URBAN RENEWAL AGENCY MEETING PACKET

A. Hwy 99 Pedestrian Bridge Project (Craig Sheldon, Public Works Director)

Sherwood 99W Pedestrian Bridge Crossing Value Engineering Work Session City Council

Meeting Objective

VE Option #3: Delete East Stair

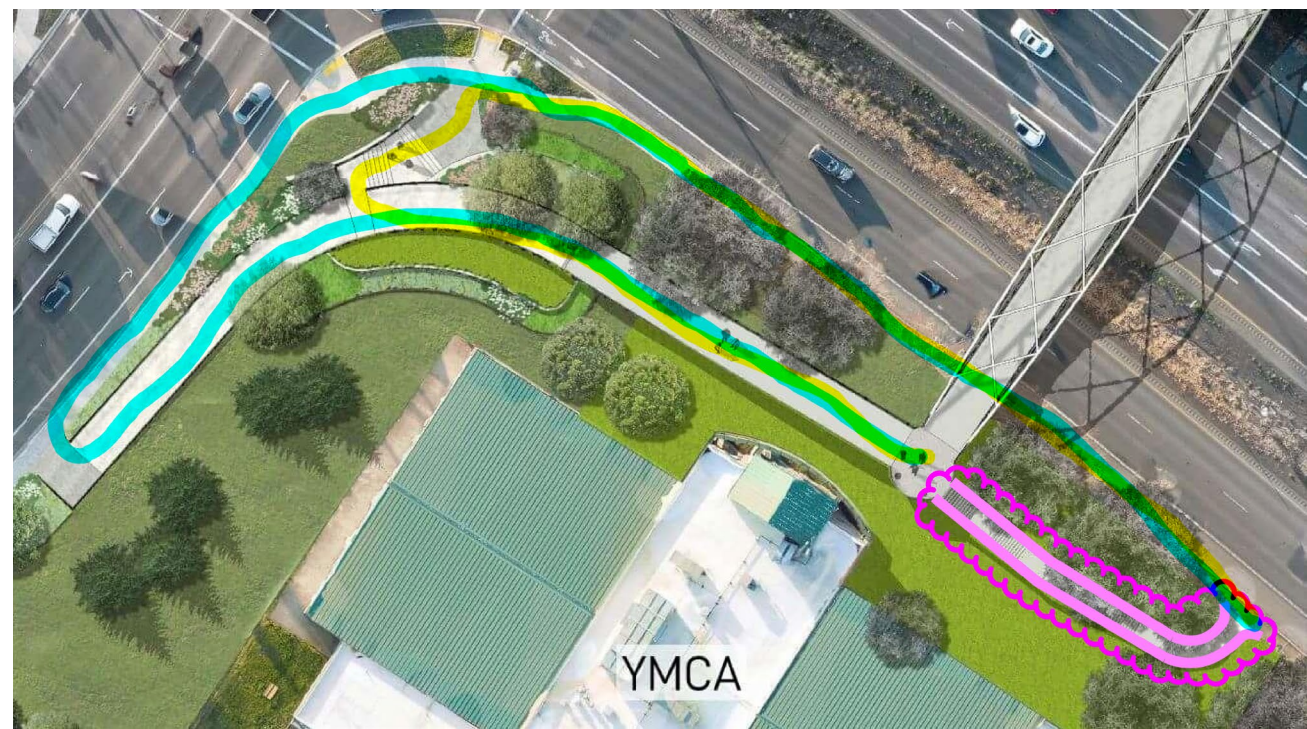
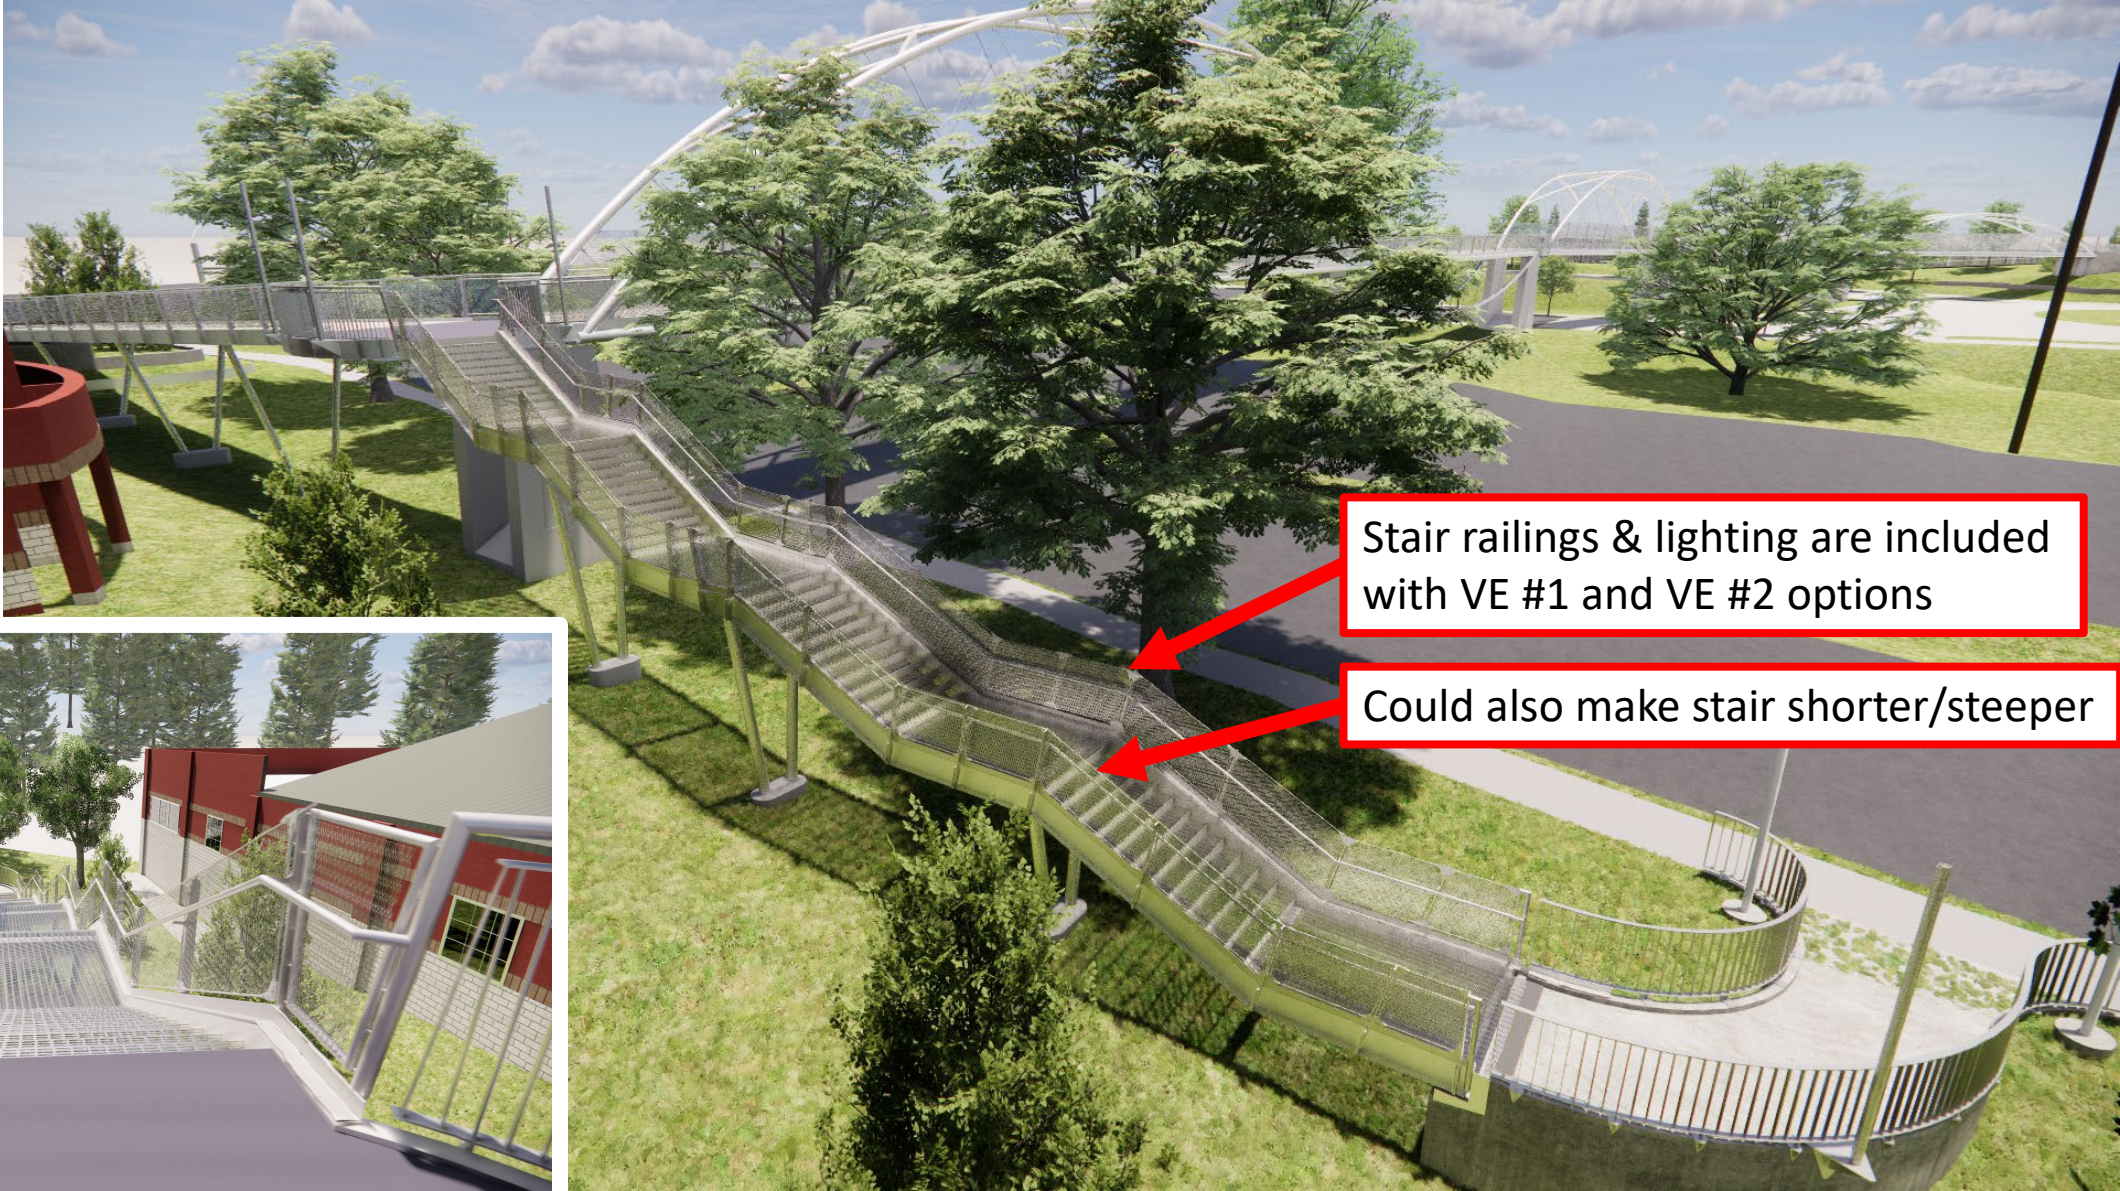
- A. **Delete East Approach Stair** down to Hwy. 99W NB Sidewalk
- B. Increases path of travel in this direction by approx. 450 ft
- C. Accessible path of travel in this direction is approx. 850 ft

Approx. **\$700 k to \$800 k** Savings

Stair railings & lighting are included with VE #1 and VE #2 options

East Stair Current Design

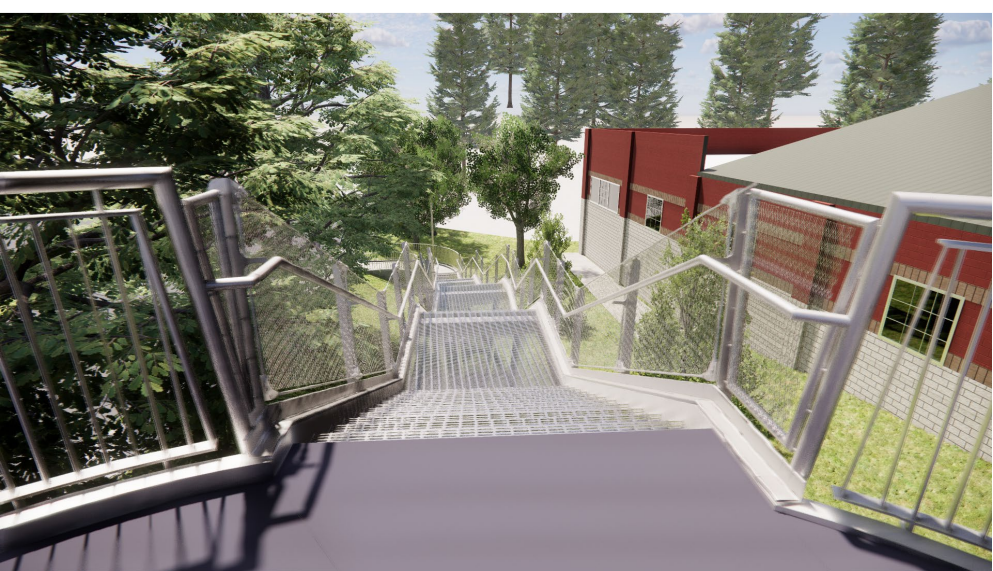
Could also make stair shorter/steeper

VE Option #4: East Approach Ramp Railings

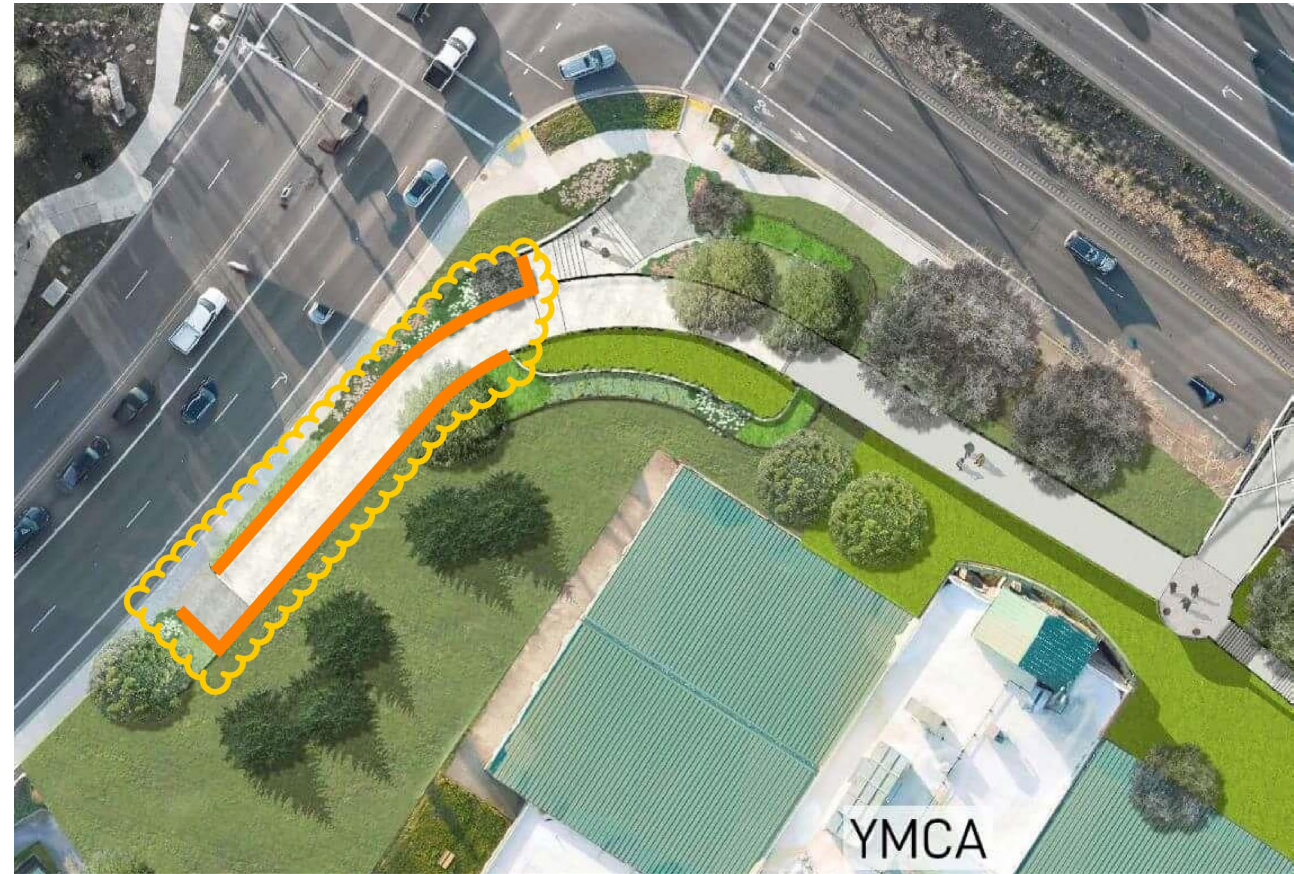
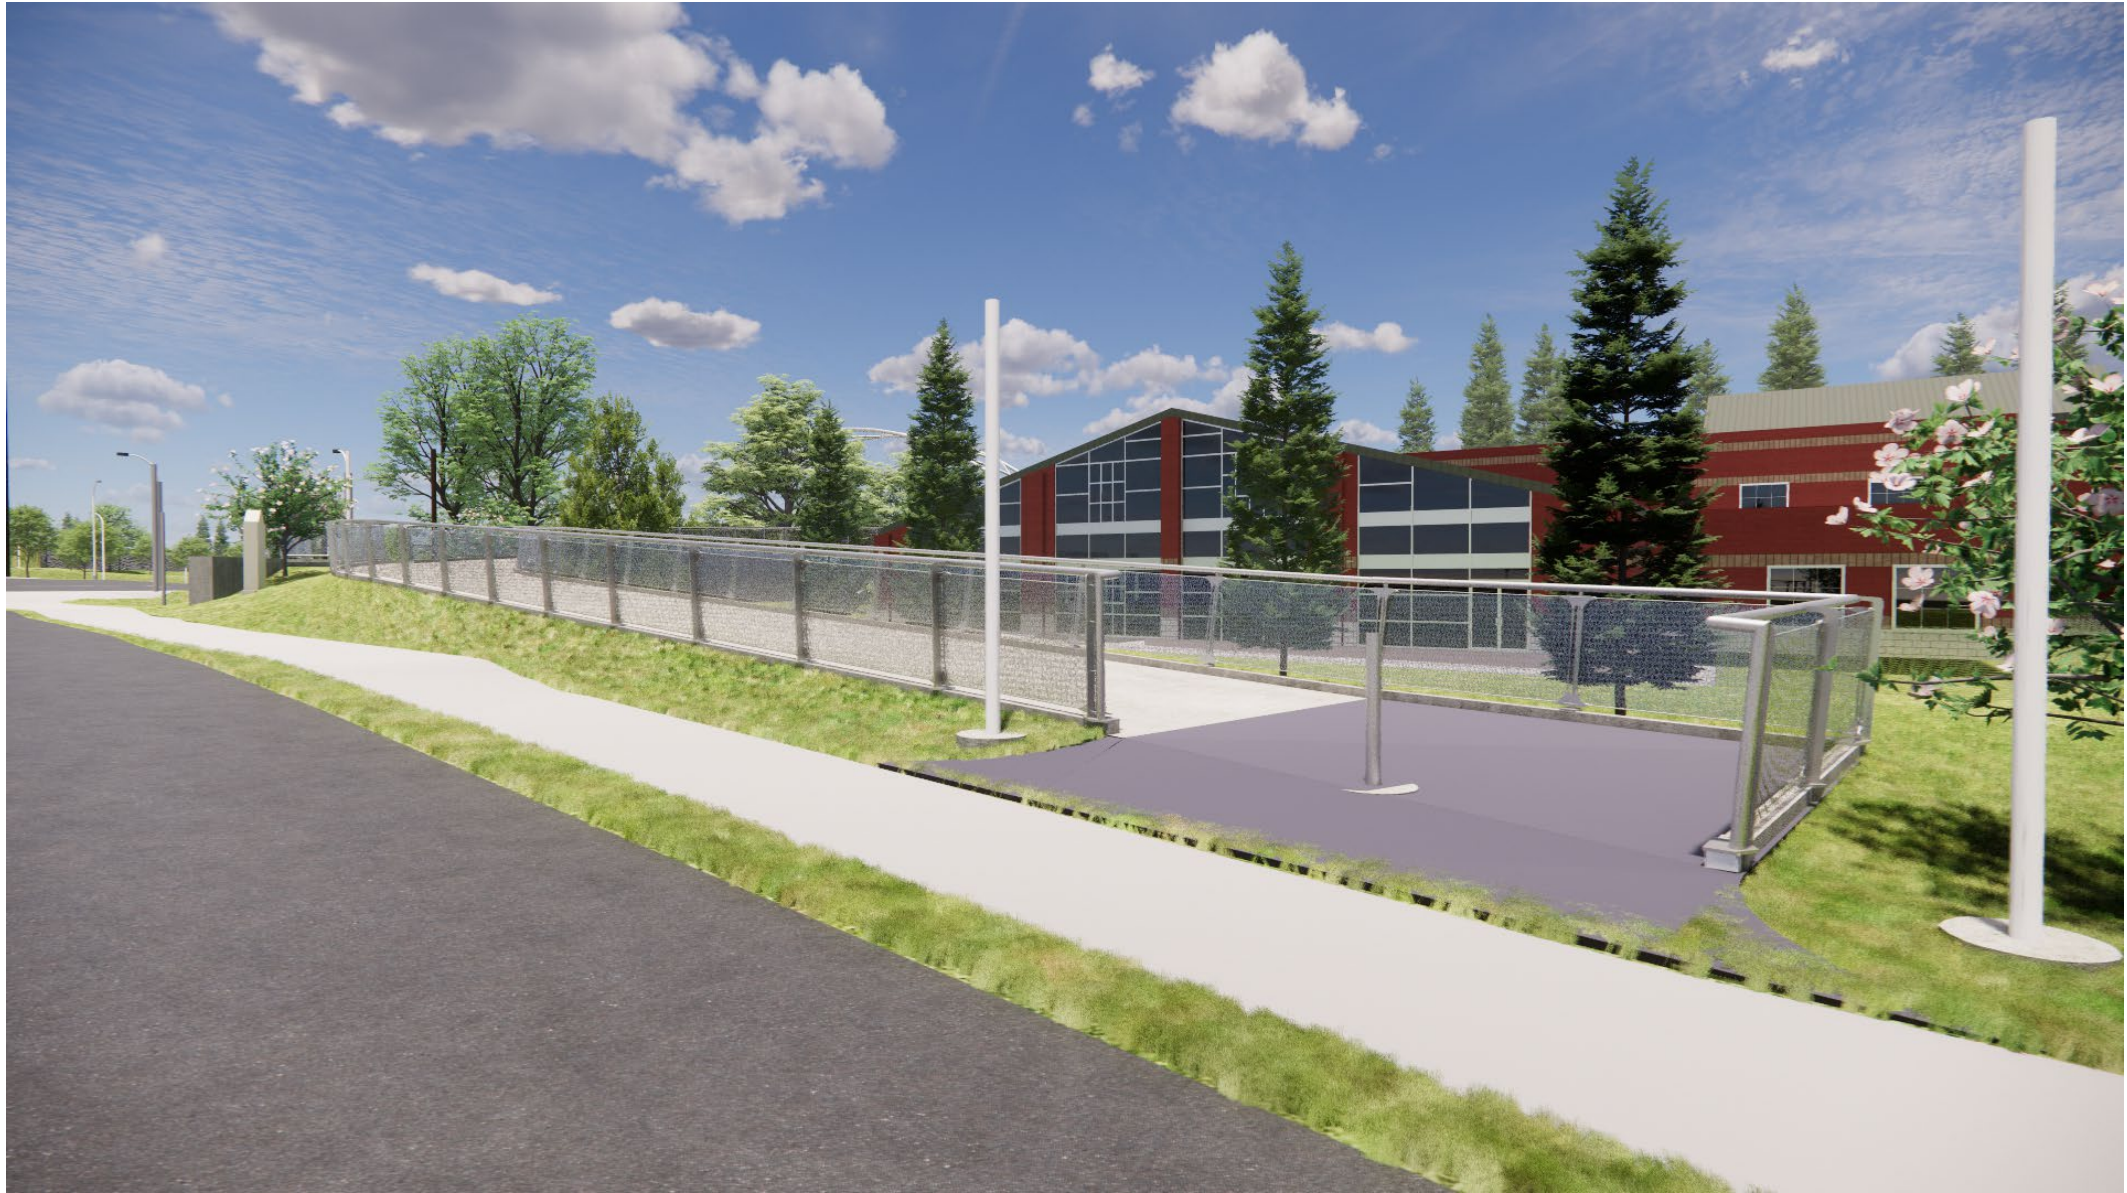
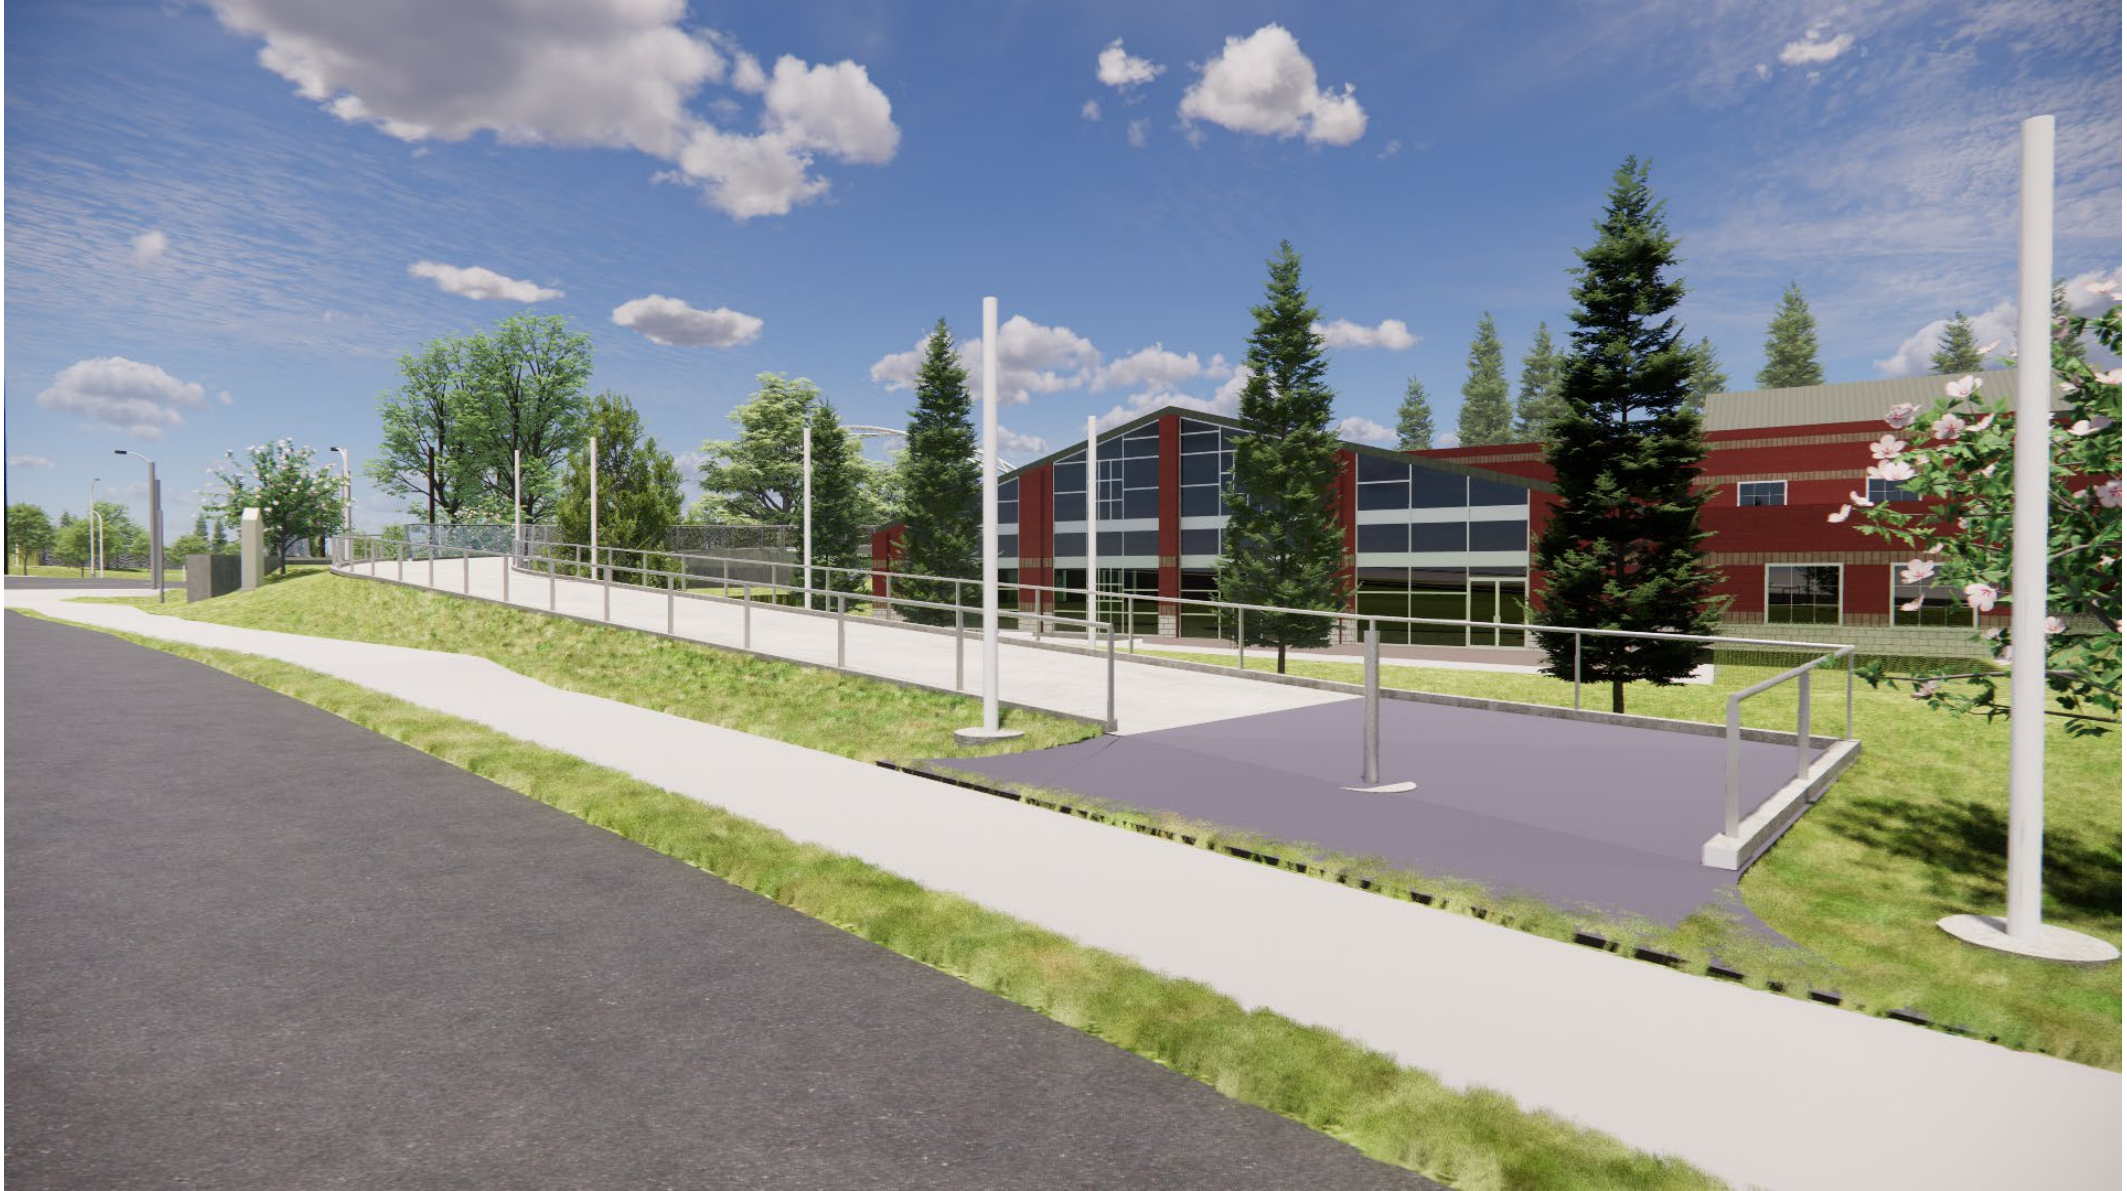
- A. Delete railings not required by code** at East Approach Ramp to Sunset Blvd.
- B. Replace illuminated railings with pole lights
- C. Optionally add back simplified handrails

Approx. **\$400 k to \$500 k Savings**

East Approach Ramp at Sunset – Current

East Approach Ramp at Sunset – VE #4

East Approach Ramp at Sunset – VE #4b
